ILLINOIS POWER COMPANY

Docket No. 50-461

Subject: Clinton Power Station
Surveillance Testing

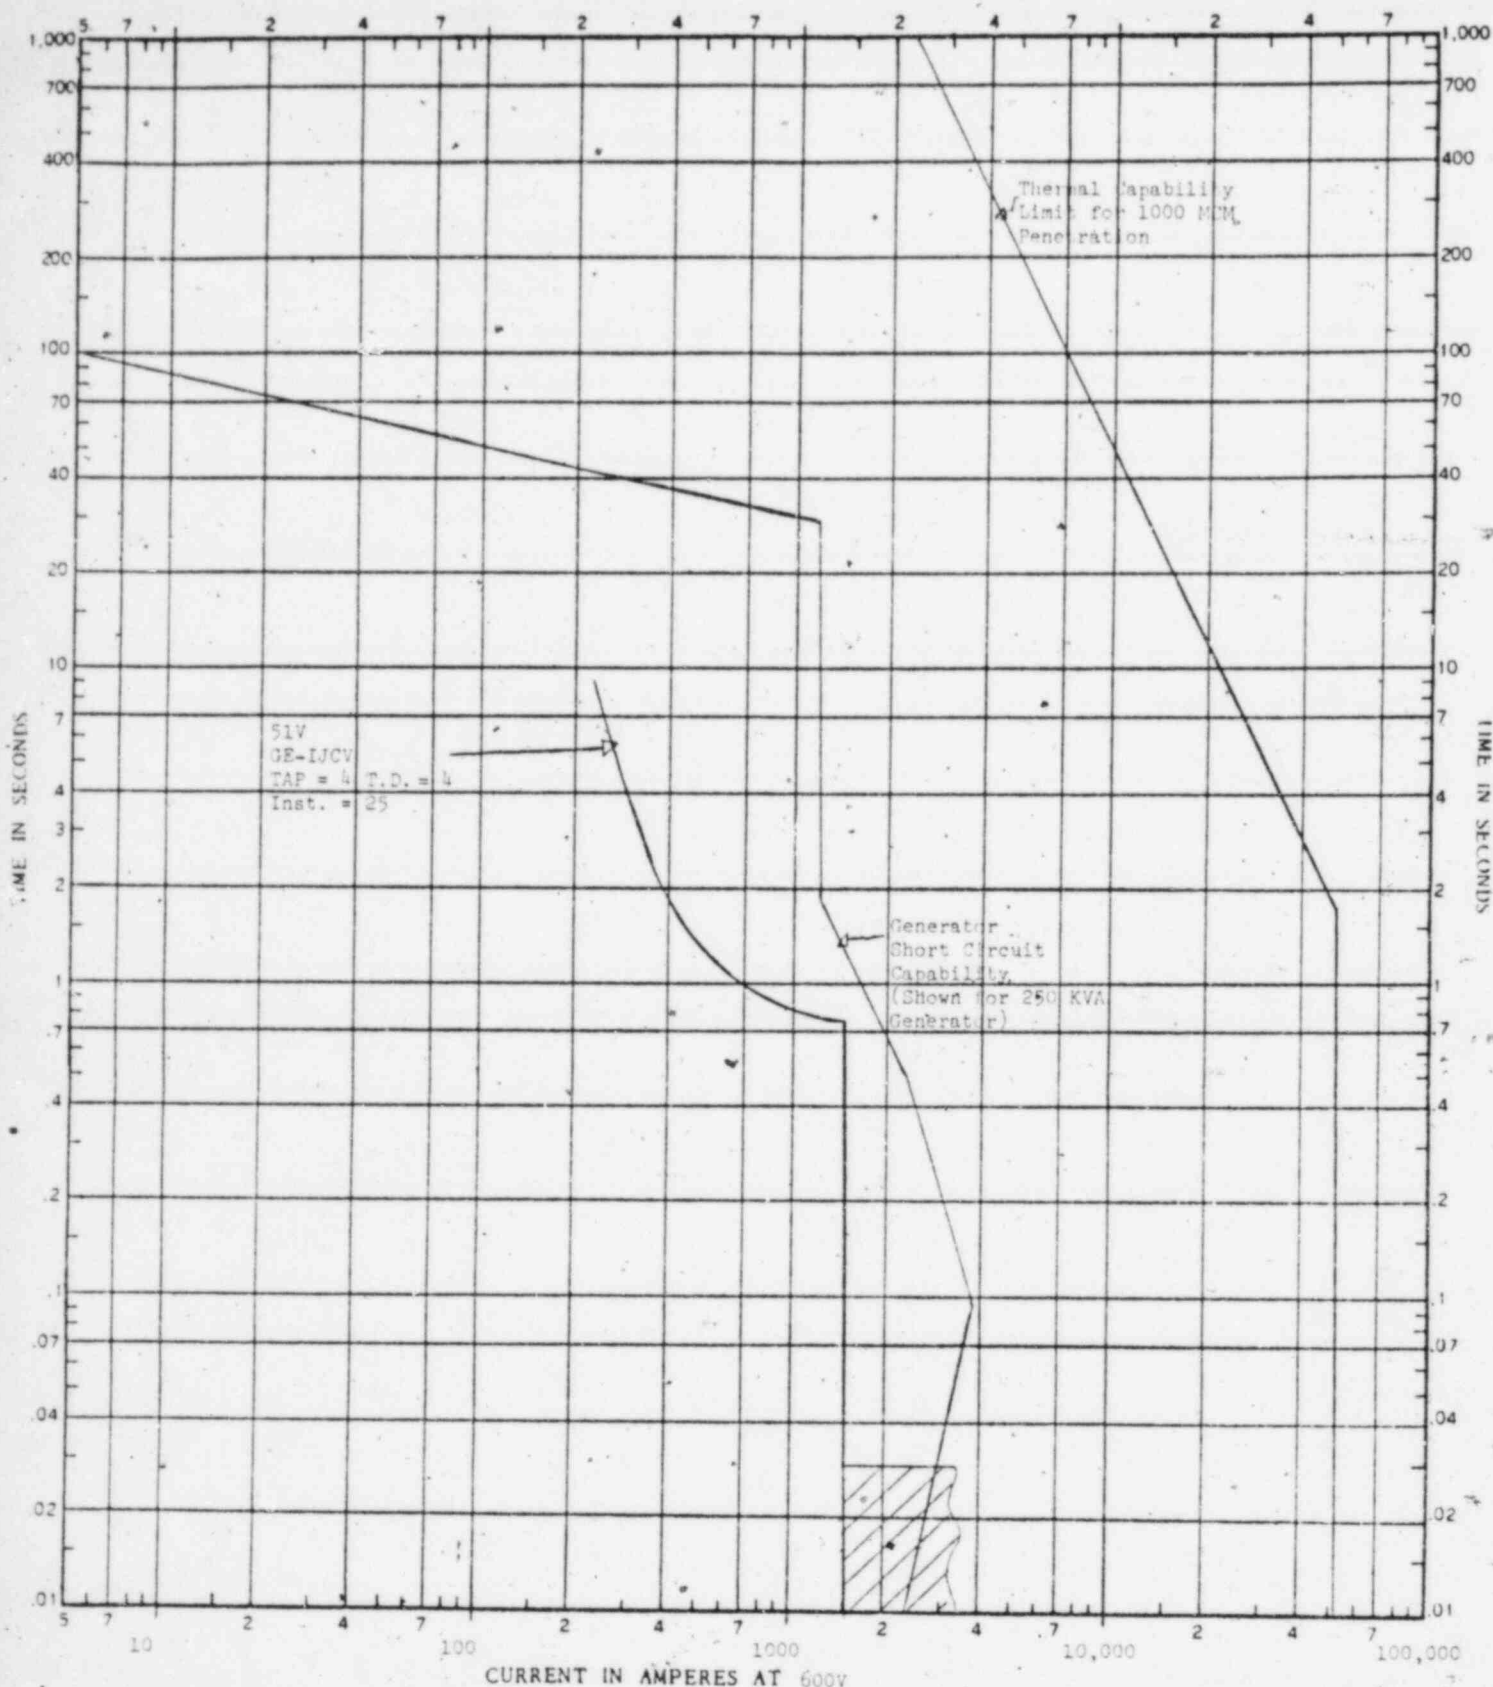
Attached is the revised Technical Specification on the Low Frequency Motor Generator (LFMG) set output breaker over current devices. The plots of current squared times time (I^2T) for the RRP power penetration, the LFMG set and the over current devices for the output breaker are attached.

If a fault occurs on the containment side of the RRP penetration, the high quality output breaker, whose I^2T let-through is below both the LFMG set and the penetration, will open to protect both the penetration and the LFMG set. If the breaker fails to open, the I^2T of the LFMG set up to and including failure of the set is below the I^2T of the penetration.
